Office Action Summary	Application No. 10/580,002	Applicant(s) MEYNET ET AL.	
	Examiner PINEL E. ROMAIN	Art Unit 4155

DETAILED ACTION

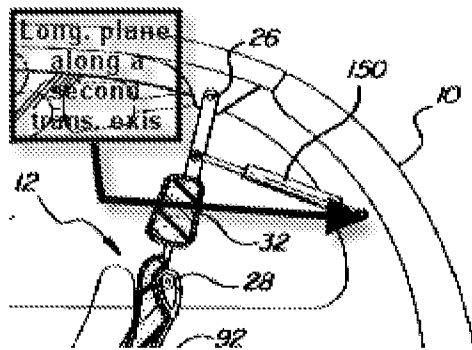
Consider claim 1: Neale discloses an adjustable seat(12) for a motor vehicle comprising of a cushion (14), a lower connecting device (42) for connecting the cushion to a lower structural element (104) of the vehicle and a backrest (16), (see fig. 2, col. 4, lines 55-58).

Neale also discloses an upper connecting device (150) for connecting an upper part (24) of the backrest (16) to an upper structural element (10) of the vehicle such as the roof of the vehicle, (col.5, and line 46).

Neale also discloses the upper connecting device (150) is suitable for forming an upper connection along side of the roof. (col. 10, lines 7)

Consider claim 2: Neale discloses the seat as claimed in claim 1, wherein the upper connecting device (150) is connected to the upper part (24) of the backrest (16) by an intermediate upper connection (28) able to allow a displacement of the upper part (24) of the backrest relative to the upper connecting device (150) with rotation along a first transverse axis where the element 150 and (26) are joined in col. 10, lines 5-8. Neale also discloses a translatory motion along a second axis (34) located in a longitudinal plane as the pivot point (22) in col. 9, lines 62-64 along the element (34) in the longitudinal plane as shown below from fig 2.
